how to do the cabling of the tracking plane?

This is a compilation of the main required inputs. Please, if you are not competent about this topic, just search for your name and answer the question attached to it.

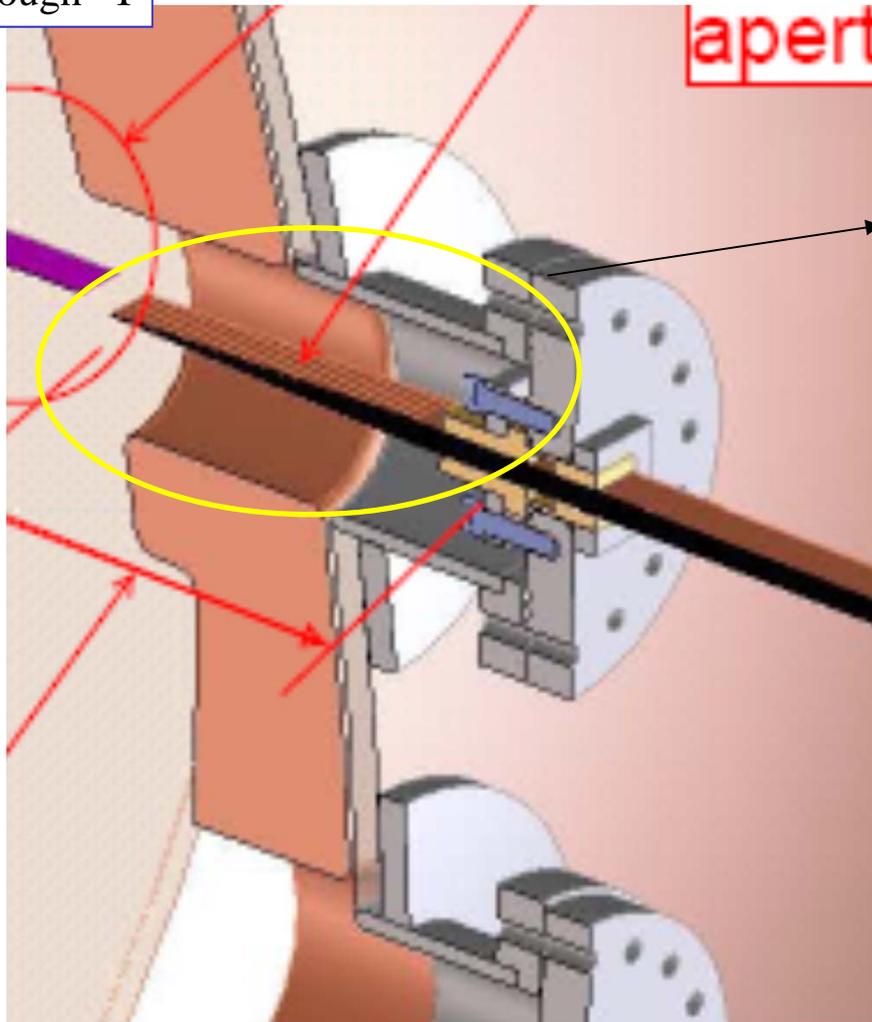
Option 2: we accept that I can describe the signal as that on a simple transimpedance amplifier with $R_{in} = 50\text{ohm}$ and a feedback loop $RC = 0.5\text{-}2\mu\text{s}$ (ideal integrator). Gain R/R_{in} is immaterial.

Feedthrough - I

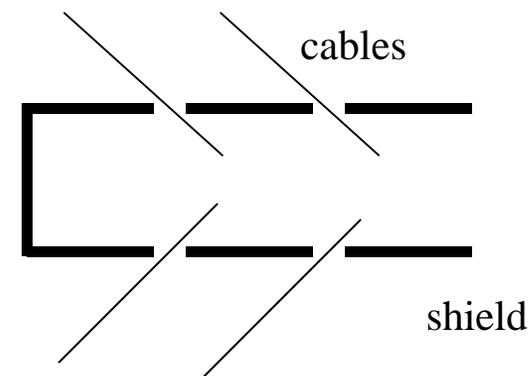
I understand that the end with the connectors falls down under gravity, **correct?** Or how far from the feed-through do we plan to do the bond-ply?. In order to shield connectors, all cables have to fit through a copper shield with some slit on it. I do not see how to easily retract 56 cables through a slit by the 20cm required for outside connection (unless some mechanism pulls from inside). **How is this done?** Perhaps one can make 4 slits. This should be even more comfortable over 4 feed-throughs (see later). Means ~ 7 cables/slit. However not sure it is doable even then...

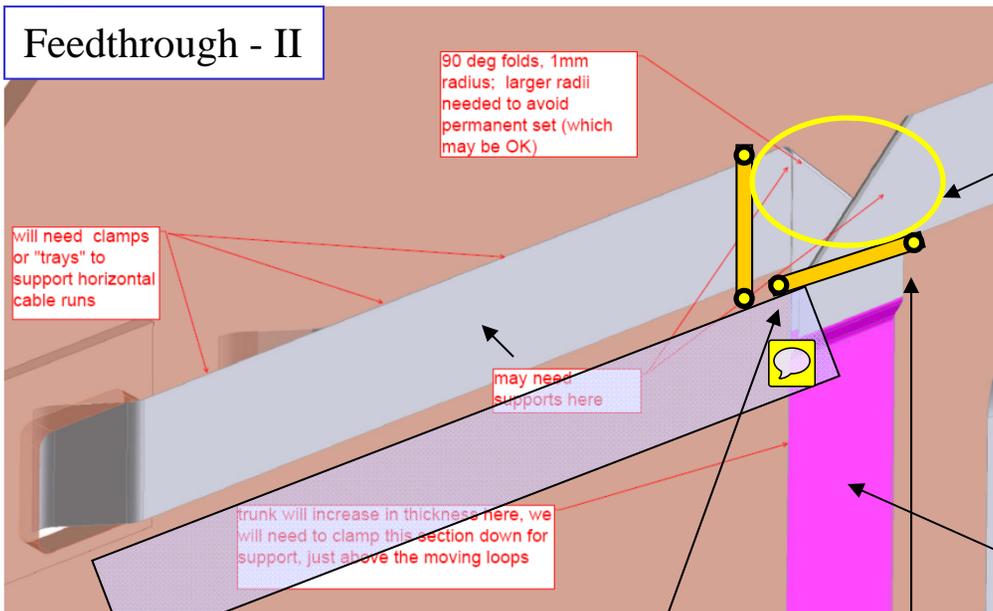
In any case, in case of emergency it seems one might want to access the inside (opening the head) while pushing the feed-throughs inwards, in order to ensure that cables are retracting properly?. **Do we require some additional ~15cm length for this contingency?**

Feedthrough - III

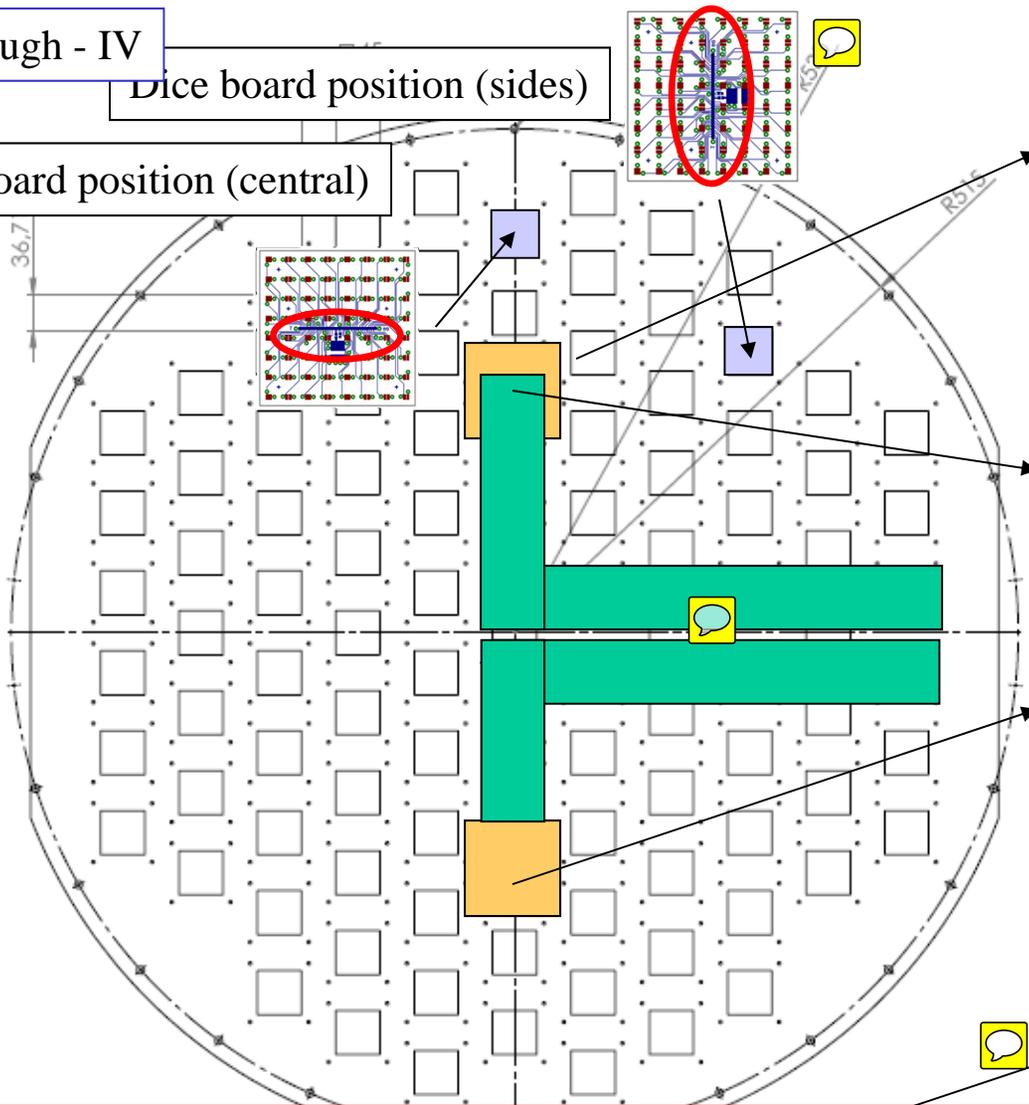
I can not find a way how the cable carriers can be used. In the hanging loops?. But what about clearance between cables then?. And why is this needed?. In the proposed arrangement everything follows nicely straight tracks.

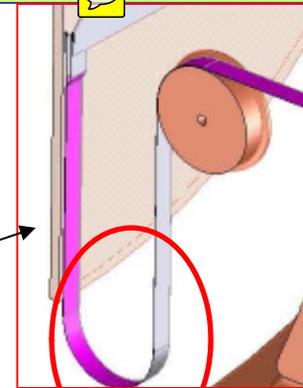
Will the wheels be placed in front of the flange?. This seems to be a good idea. Will they be placed around here, perhaps?. How will they be fixed by the way?

maximum cable length $\sim 53\text{cm} + 25\text{cm} + 20\text{cm}$ (for connector access without head removal) + 25cm wheel-connector $\sim 150\text{cm}$. [Derek estimate for maximum length (120cm)].
minimum cable length $\sim 20\text{cm} + 25\text{cm} \sim 45\text{cm}$ Correct?.

Cables have to be finely tailored one by one, otherwise even if the Dice-Boards are placed in the right order, the corresponding hanging loops will not fit. **Might not be a problem if the cables can be cut by hand to the right length?** Buying all cables with different lengths I fear it will be unacceptable money-wise (**am I wrong?**). Cutting by hand might not work since it seems one typically needs one end with, e.g., sculptured traces (for the Dice-Board) and the other end with ZIF-compatible traces.

I might propose...
the super-duper
random-accordion
scheme

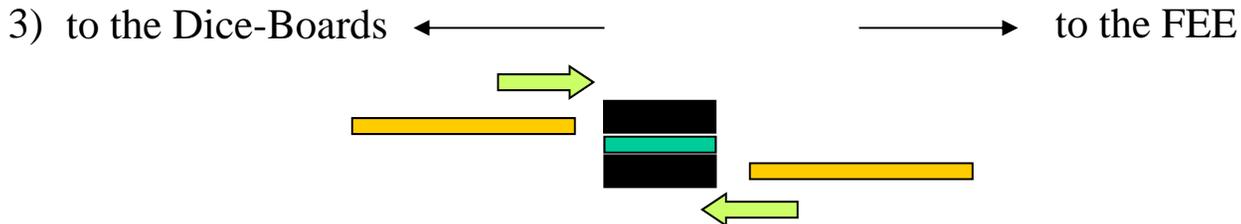
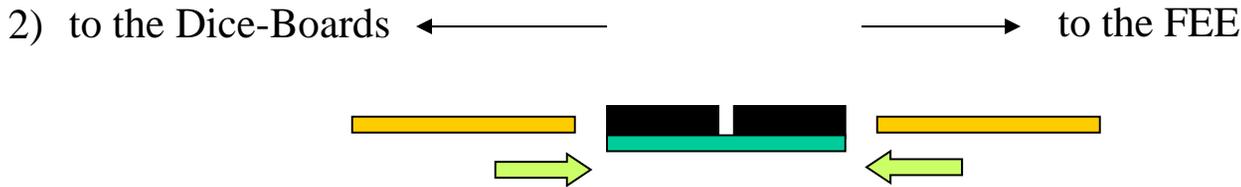
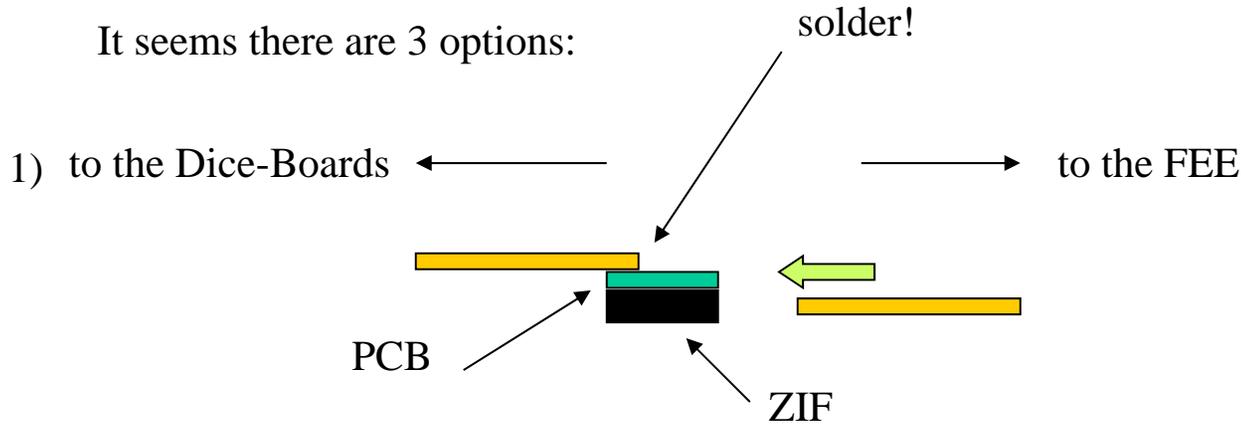
use just 4 feed-throughs and route the cables following reasonable pre-defined rules. Then all cables can be used with the *same length*, ~approximately 50-75cm. With these dimensions I think it should usually work. If it does not, then try again. At most you have to undo some part of 1/4th of the carrier plate. Dice-boards can be assembled and disassembled anytime without touching the rest. Even better if it would be possible to access them from the back of the carrier plate. Material budget will be considerably less. Back to back ZIF on-board connectors can be used for connecting feed-through cables with Dice-Board cables (with 4 feed-throughs there is enough space). Clearance between cables will be naturally respected (at least to a larger extent than in previous scenario). **It is easy to build a mockup and test it.**
